# Council Assessment Panel Agenda & Reports

**16 May 2022**

**2.1 DEVELOPMENT APPLICATION 21042128 – DESIGN INC ADELAIDE PTY LTD  
 - 84 PORTRUSH ROAD, 5 TARCOMA AVENUE, PAYNEHAM SOUTH**

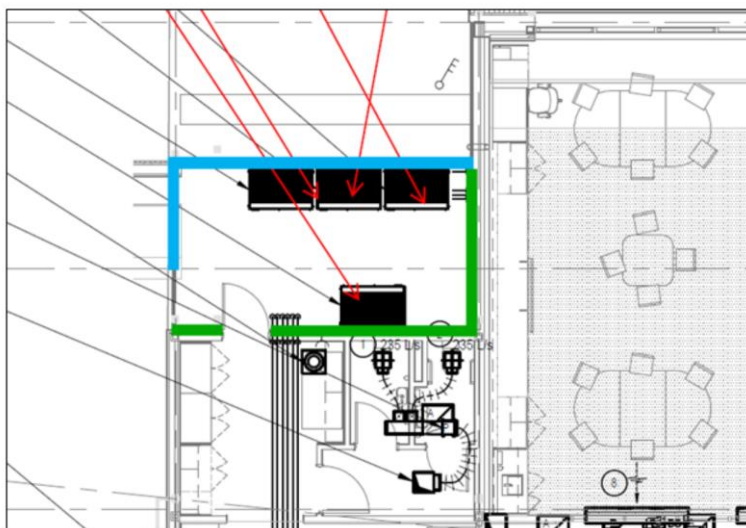
The application has been reviewed by Sonus acoustic engineers. Sonus have assessed the noise impacts of the mechanical plant associated with the proposed school building. Sonus have made the following recommendations to meet the goal noise levels.

- Construct a screen around the plant area, as shown in BLUE below, to a height of 2.2m. The screen should be sealed airtight at all junctions, including the ground, and may be constructed from a solid material (such as sheet steel), or acoustic louvres with acoustic performance equivalent to the Fantech SBL1 Louvres.

- Install acoustic absorption to the walls of the plant area for the extent shown in GREEN below. This should extend to the same height as the screen, being 2.2m. This absorption should be constructed as 50mm thick polyester insulation (with a minimum density of 32kg/m<sup>3</sup>) installed behind a perforated product such as timber or sheet steel in accordance with Figure 4. Alternatively, any proprietary product with an NRC of at least 0.6 may be used

2. A screen shall be constructed and maintained around the plant area, to a height of 2.2m. The screen should be sealed airtight at all junctions, including the ground, and may be constructed from a solid material (such as sheet steel), or acoustic louvres with acoustic performance equivalent to the Fantech SBL1 Louvres.

3. Acoustic absorption shall be installed to the walls of the plant area. This shall extend to the same height as the screen, being 2.2m. This absorption shall be constructed as 50mm thick polyester insulation (with a minimum density of 32kg/m<sup>3</sup>) installed behind a perforated product such as timber or sheet steel. Alternatively, any proprietary product with an NRC of at least 0.6 may be used.
